HOMOLOGATION AND TECHNICAL SPECIFICATION UPDATE BULLETIN

HOMOLOGATION	Rotax 125 Junior Max	HOMOLOGATION NO.	112H
BULLETIN NO.	Rotax 9 Junior Max	BULLETIN DATE	9 December 2016
SUBJECT	Support Plate System for Junior Max Ignition Coil

Support Plate System for Rotax 125 Junior MAX

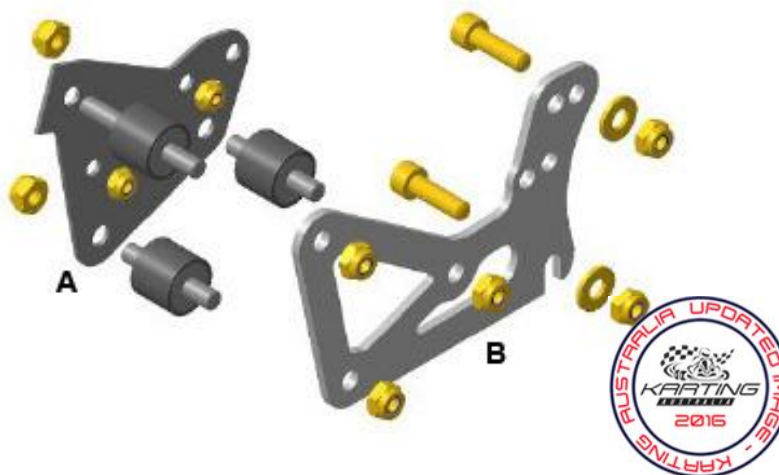
The new support plate system for mounting the ignition coil and magnet valve is a more compact system with less electrical connections at the backside of the engine, and the ECU now located in the battery housing. This system creates less risk of interference from any chassis components.

(A) Mounting Plate (Part No. 651 925)

(B) Retaining Plate (Part No. 651 935)
